SVT Silicon Disks Clearances for Removal

Notes 7 May 2024

Hard Geometry Check

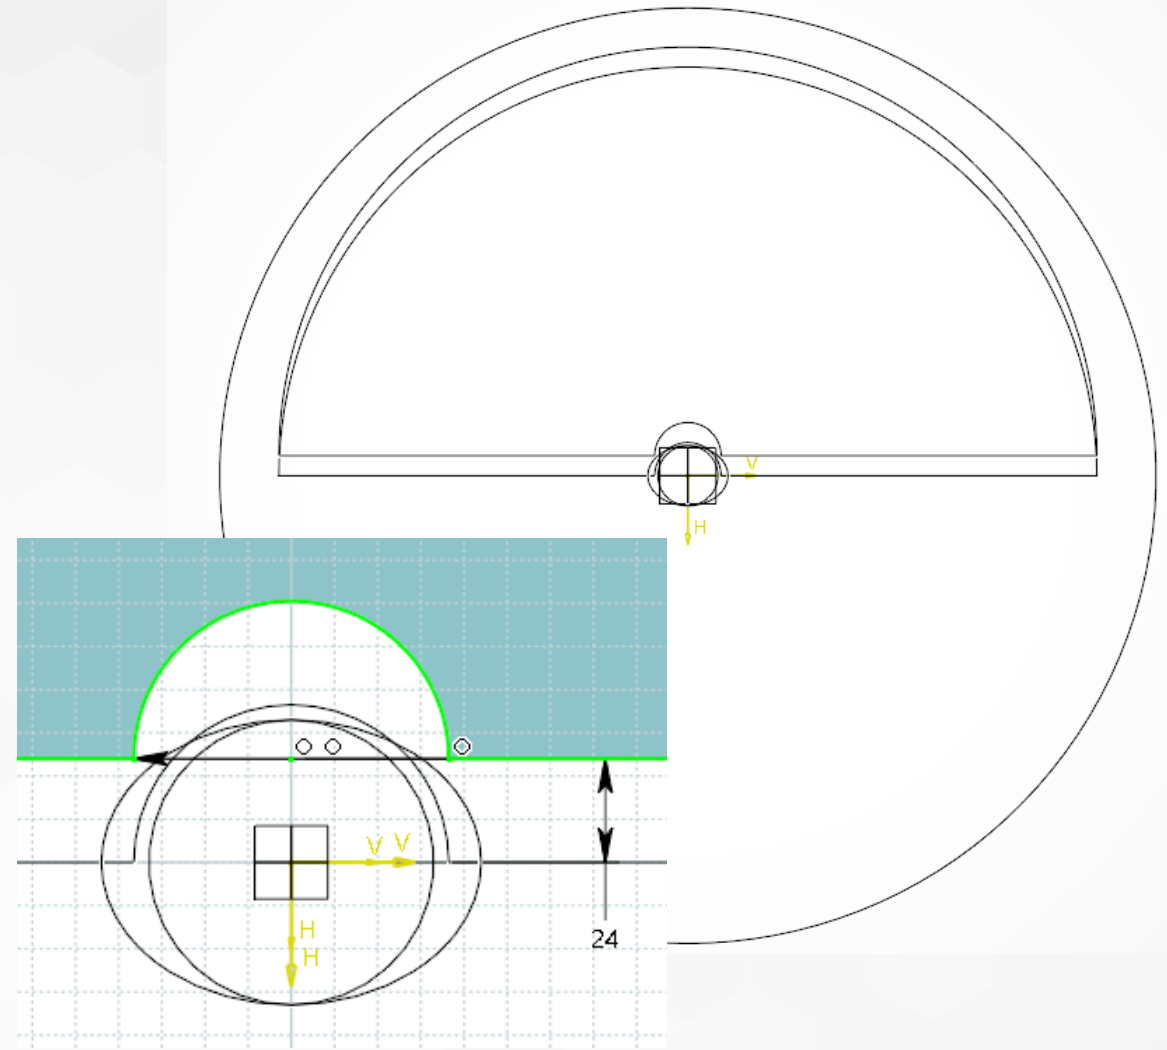
- Can Si disk move up enough to clear beampipe at exit from SVT space?
 - Ignore “soft” services for now
 - Move disk up into services gap as it moves outward in Z
- Needs to move up ~24mm+
 - Current disk frame-to-“PST” gap only 10mm – smaller frame? Larger PST?
- Additional disk overlap to consider
